REVISION 001 TO A INVITATION TO TENDER

Title - Sujet : Mechanical Systems Upgrade, Battle of the Restigouche National Historic Site		
Solicitation No. - N° de l'invitation : 5P468-21-0158/A	Date : 08 December 2021	
Amendment No. - N° de modification : 001		
Client Reference No. - N° de référence du client : 1408		
GETS Reference No. N° de référence de SEAG : PW-21-00975348		
Solicitation Closes - L'invitation prend fin : At - à : 14 :00 On - le : 16 December 2021		Time Zone - Fuseau horaire EST
F.O.B. - F.A.B. : Plant - Usine : <input type="checkbox"/> Destination : <input checked="" type="checkbox"/> Other - Autre : <input type="checkbox"/>		
Address Enquiries to - Adresser toutes demande de renseignements à : Jaime Creaser		
Telephone No. - N° de telephone : 902-266-8592	Fax No. -N° de télécopieur : 1-877-558-2349	Email Address – Courriel : Jaime.Creaser@pc.gc.ca
Destination of Goods, Services, and Construction - Destination des biens, services, et construction : See Herein

File : Mechanical Systems Upgrade
APC Project : 1408-4

Addendum No : ME-01

Alternatives to fire watch

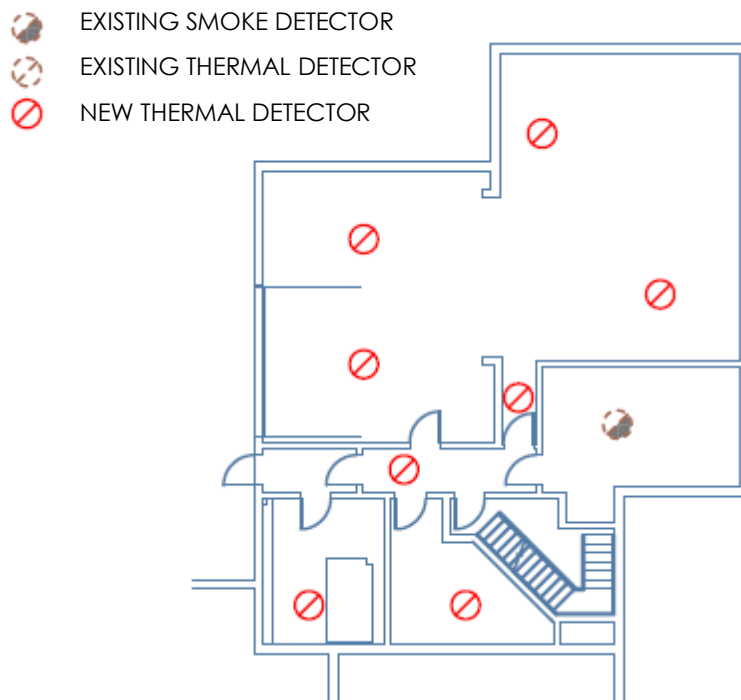
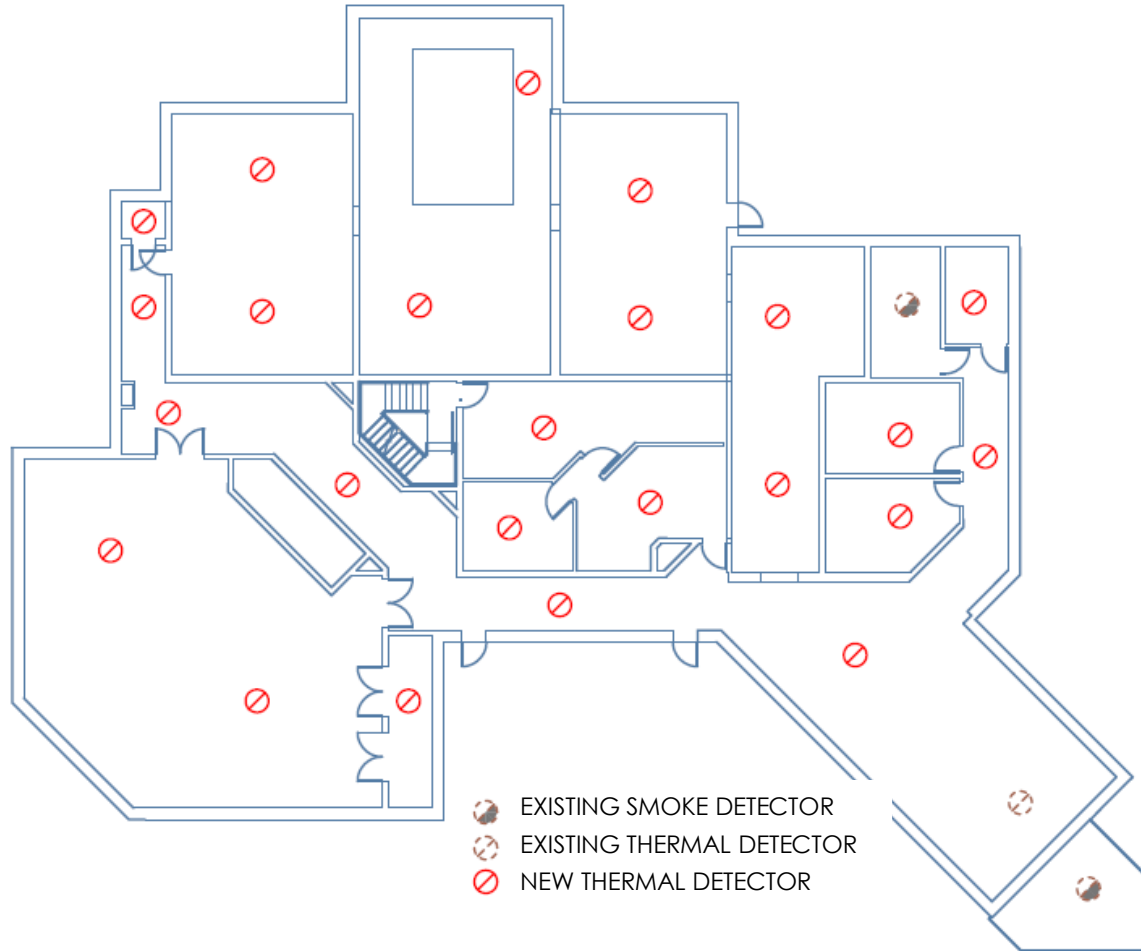
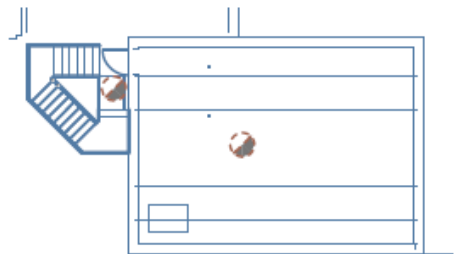
Following the addition of the communicator module, the pumps of the fire protection system will be dismantled and the sprinklers will not be functional for a certain period of time. As an alternative to fire watch, the Contractor may provide for the addition of a network of temporary heat detectors throughout the work period on the fire protection system. Some detectors are already existing but new detectors are needed to provide full coverage. The following sketches show the temporary detectors to be provided for the project, if this alternative is chosen by the Contractor. Refer to plan A01 for views of each floor, to scale.

Provide conventional wired heat detectors in the building premises as shown in the previous sketches.

Provide wireless communication heat detectors in the building premises as shown in the previous sketches.

SOUS-SOL - DÉMOLITION / BASEMENT - DEMOLITION
 ECHELLE - SCALE 1 : 100

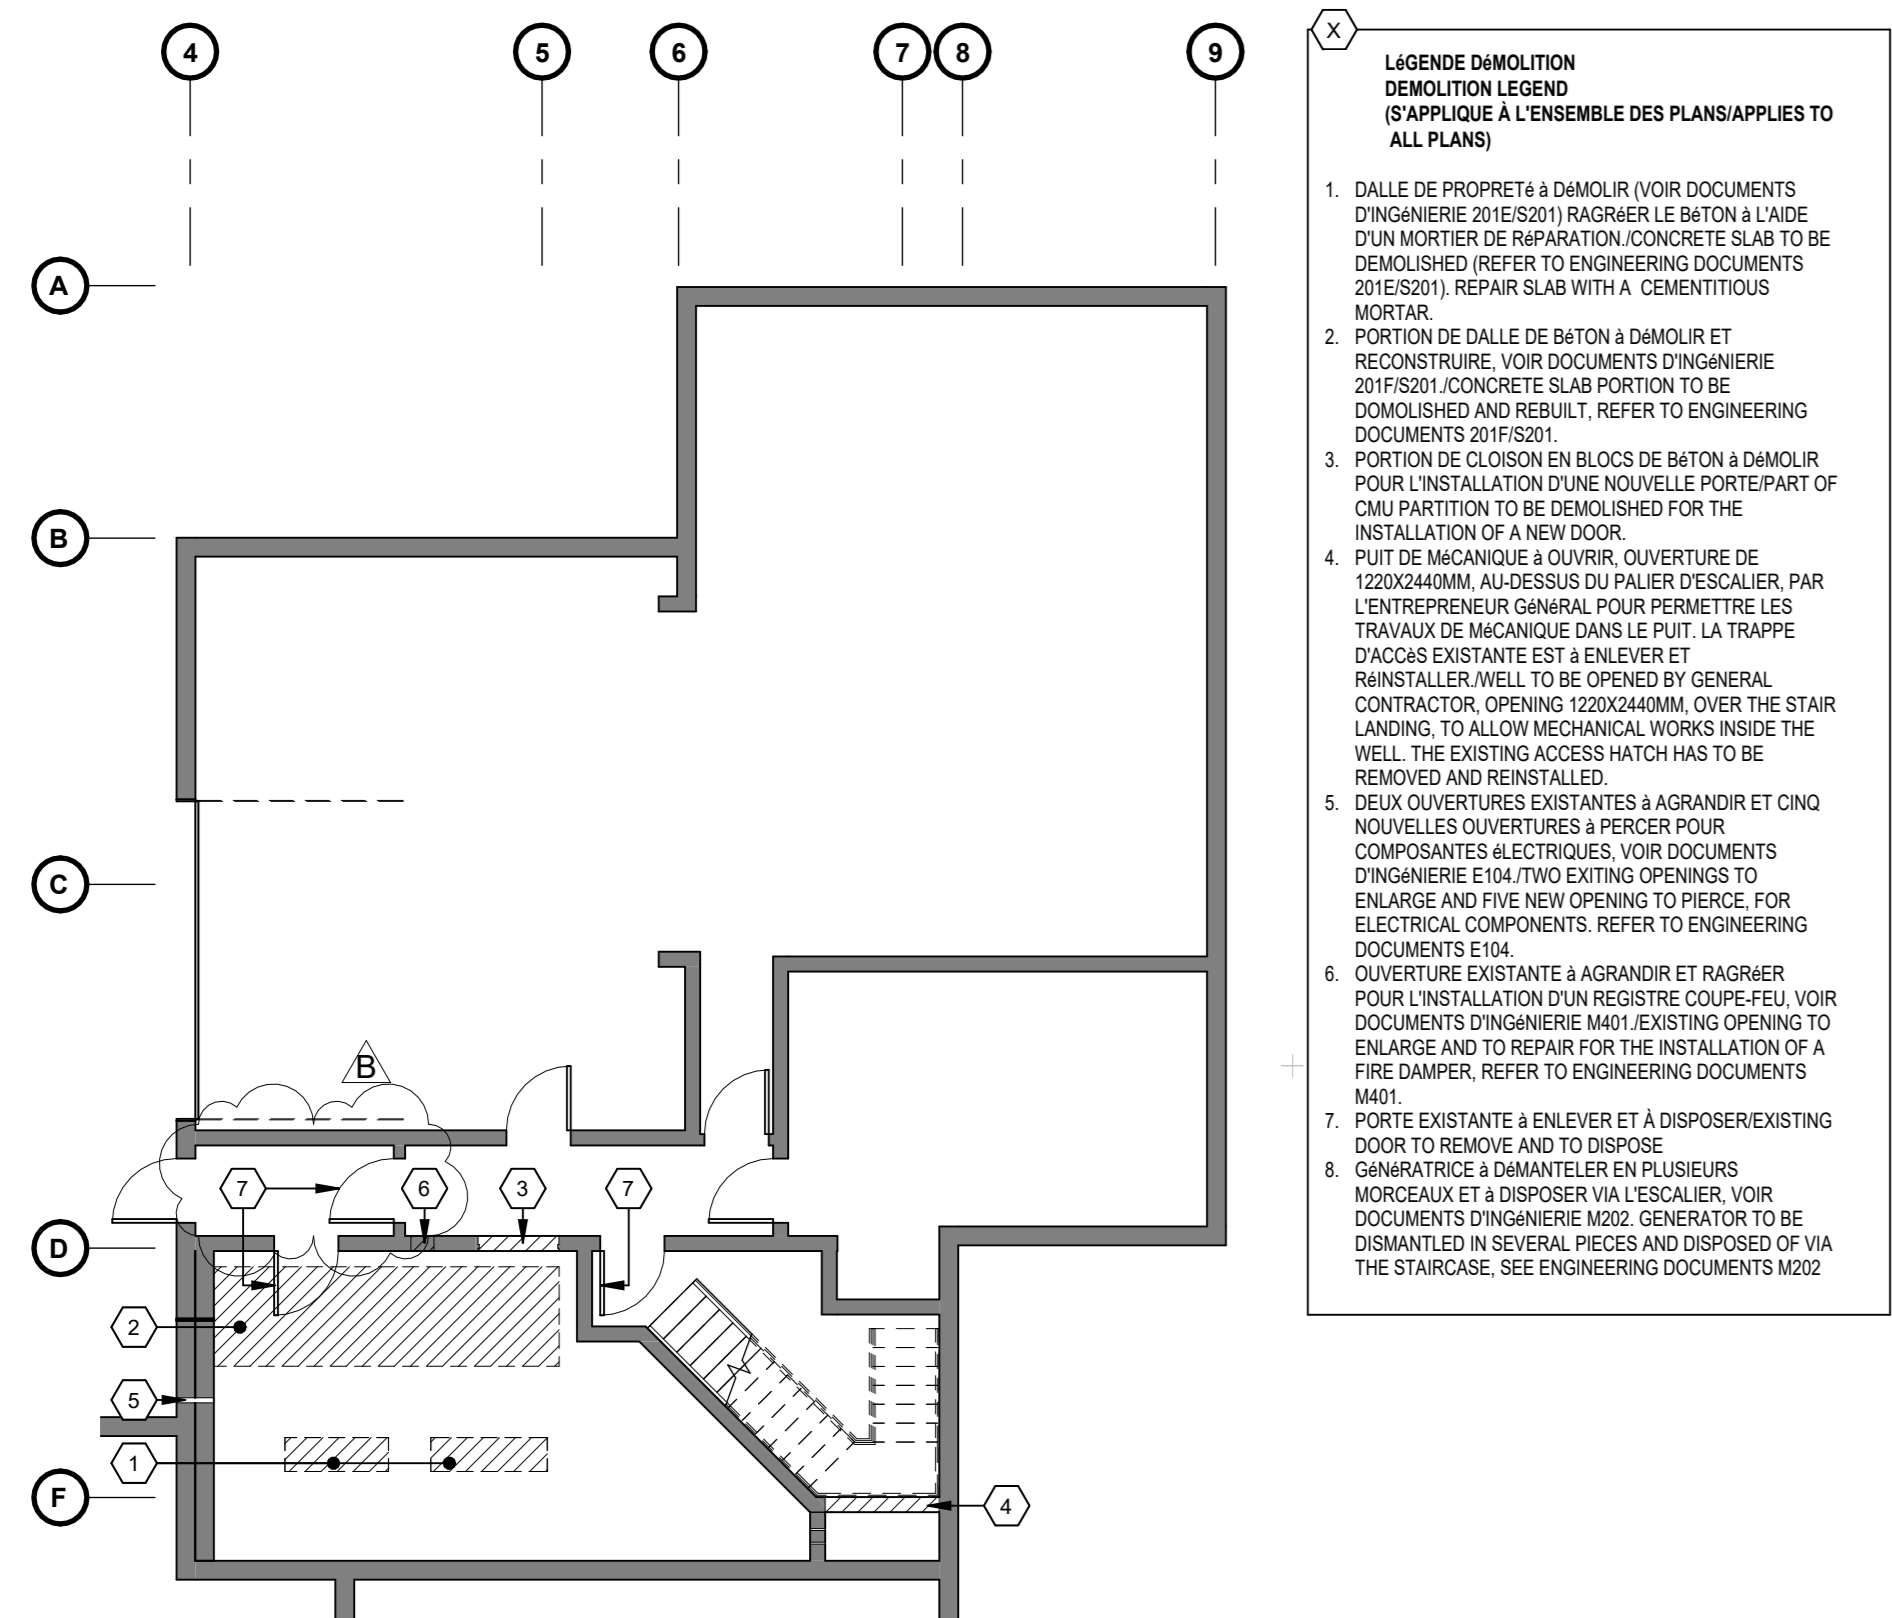
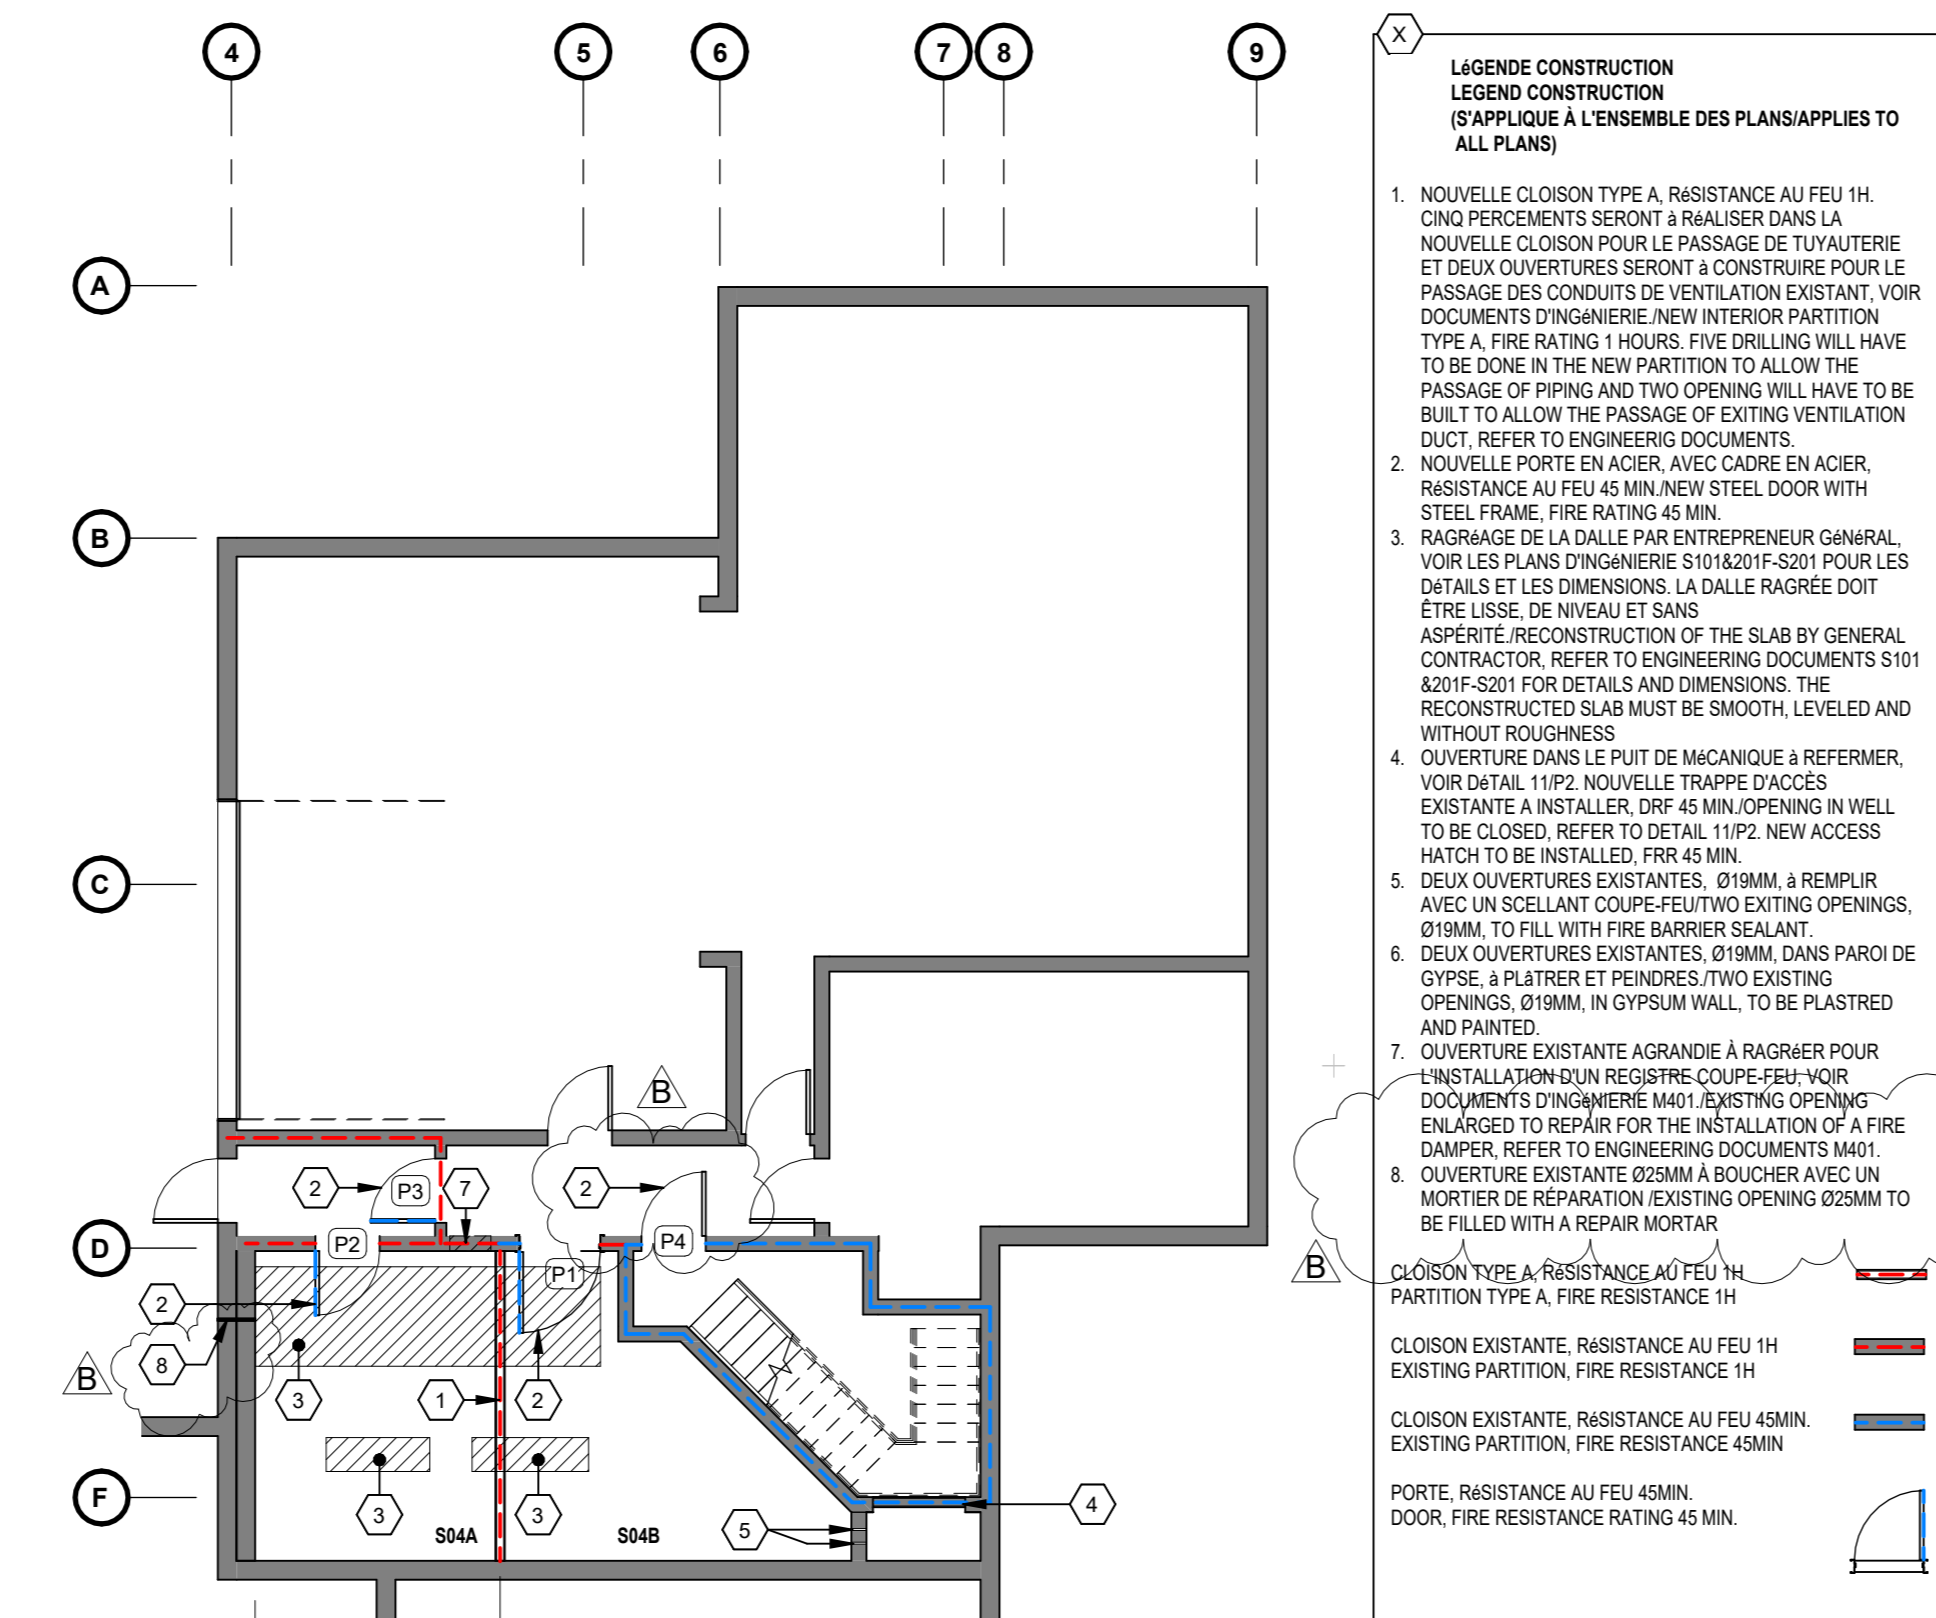
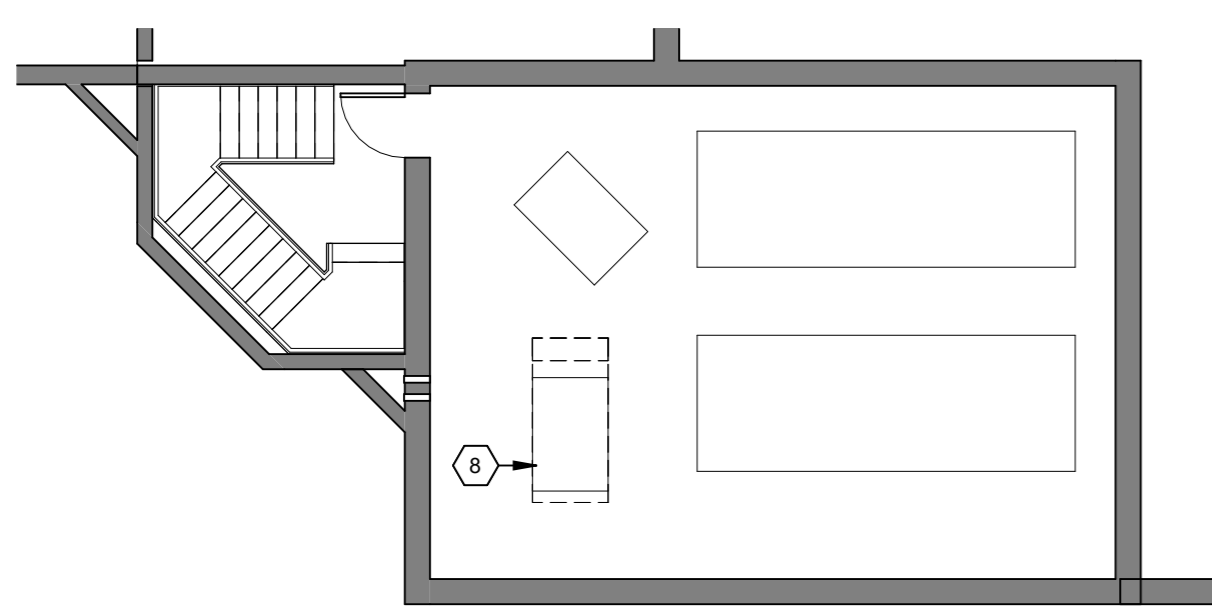
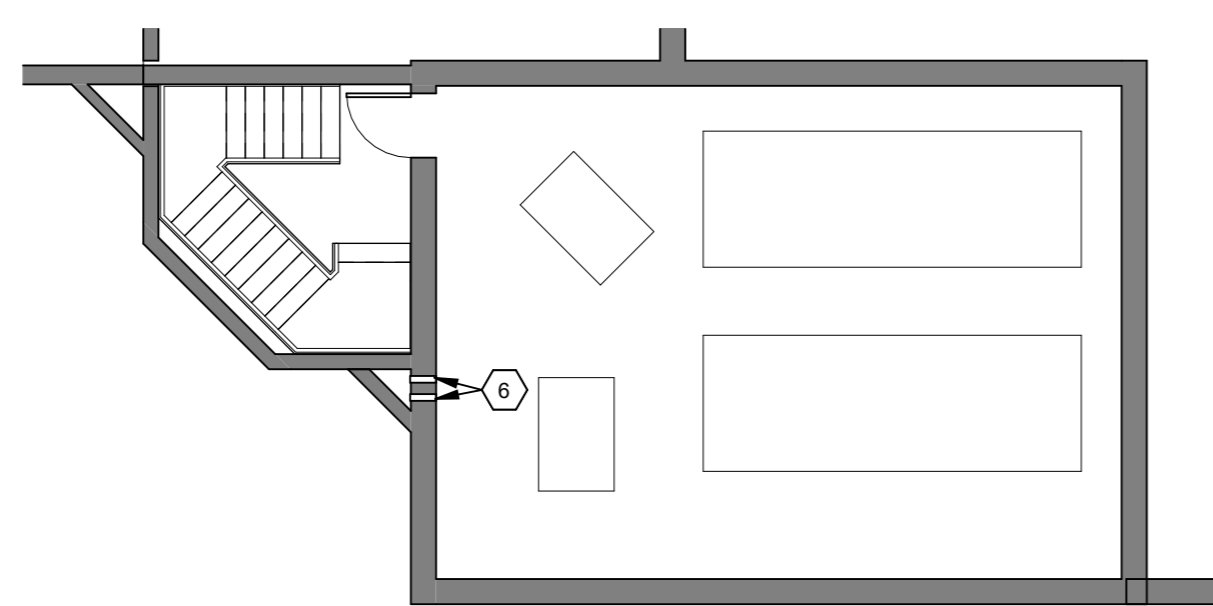
- a) **Page A02 – Plan SOUS-SOL – DEMOLITION : Une note est ajoutée concernant la démolition de la porte dans le corridor. / Sheet A02 – Plan BASEMENT – DEMOLITION : A note is added regarding the demolition of the door in the corridor.**
- b) **Page A02 – Plan SOUS-SOL – CONSTRUCTION : Une ouverture à boucher est ajoutée dans le mur extérieur. / Sheet A02 – Plan BASEMENT- CONSTRUCTION : An existing opening to be closed is added in the exterior wall.**
- c) **Page A02 – Plan SOUS-SOL – CONSTRUCTION : Le sens d'ouverture de la porte P4 est modifié. / Sheet A02 – Plan BASEMENT – CONSTRUCTION : The direction of door swing of the door P4 is modified.**
- d) **Page A02 – LÉGENDE – CONSTRUCTION : La note 8 est ajoutée. / Sheet A02 – LEGEND – CONSTRUCTION : The note 8 is added.**
